**RE: Proposed Residential Development, Dorothy Road, Arlington, Massachusetts  
Request for Preliminary Review of Applicant's Frimpter Analysis**

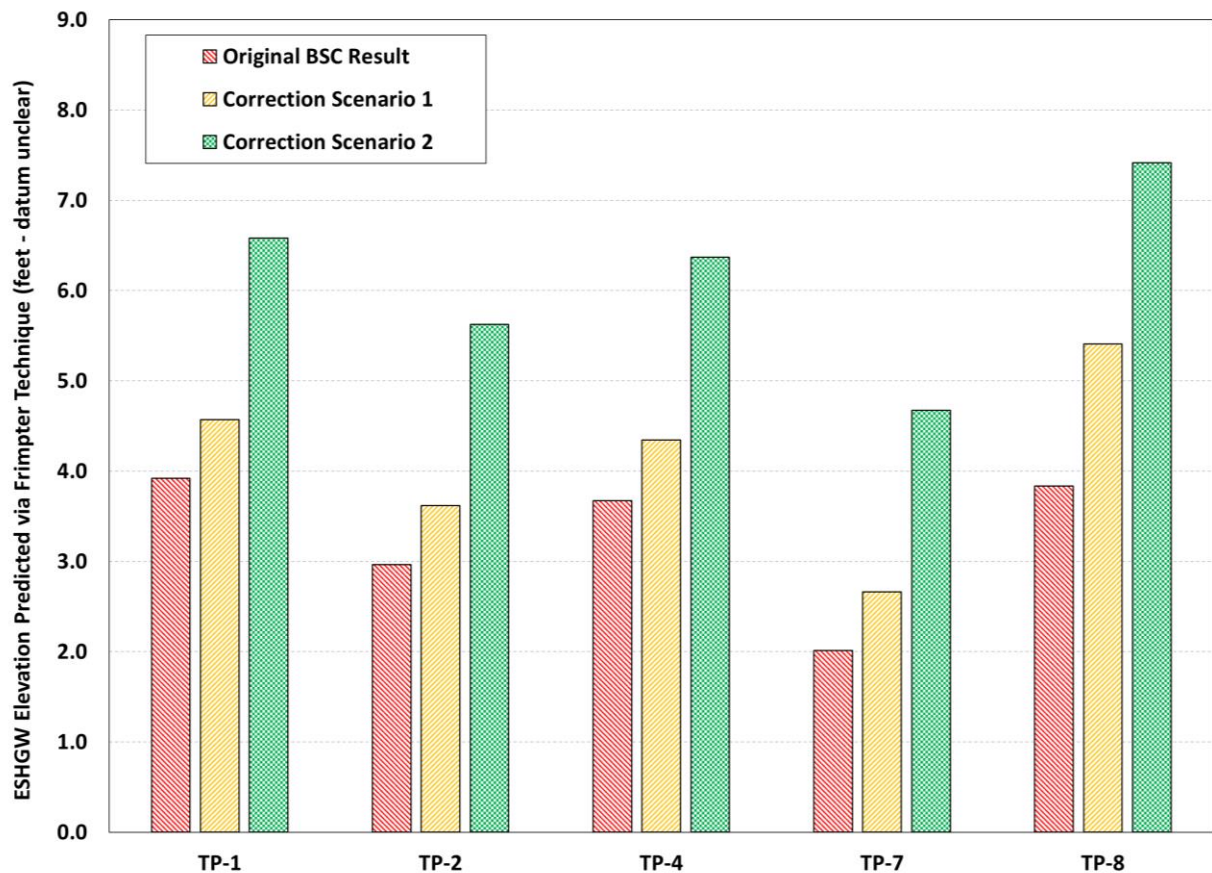
- **Issue 3 – Sr (Annual range at the test site)** – BSC selected an Sr value of 2 feet for test pit TP-8. This value appears to be an erroneous input, as it does not match the outdated or updated Sr values described above in relation to Issue 2. Again, using a larger Sr value in the Frimpter analysis will result in a higher ESHGW elevation compared to the calculations presented by BSC.

The results produced under Correction Scenarios 1 and 2 are compared to the original results reported by BSC in the following figure:

As evidenced by the figure above, when the issues identified through MMA's review are addressed through revision, the Frimpter analysis predicts significantly and consequentially higher ESHGW elevations at all of the considered test pits. For most test pits, the degree of difference relative to the original BSC estimates indicates the resultant ESHGW elevation is more sensitive to (i.e., increases more due to) the  $S_r$  value basis highlighted under Issue 2 than the  $OW_c$  value basis highlighted under Issue 1. TP-8 displays a unique sensitivity profile due to the apparent  $S_r$  value error highlighted under Issue 3.

**Correction Scenario 1:** Address Issue 1 by using daily mean groundwater depths reported by the U.S. Geological Survey at index well MA-LTW on test pit completion dates, and address Issue 3 by making the Sr value consistent with the value used for other test pits (i.e., the outdated value of 4.2 feet).

**Correction Scenario 2:** Modify Correction Scenario 1 to include an Sr value of 7.1 feet based on the updated U.S. Geological Survey study.
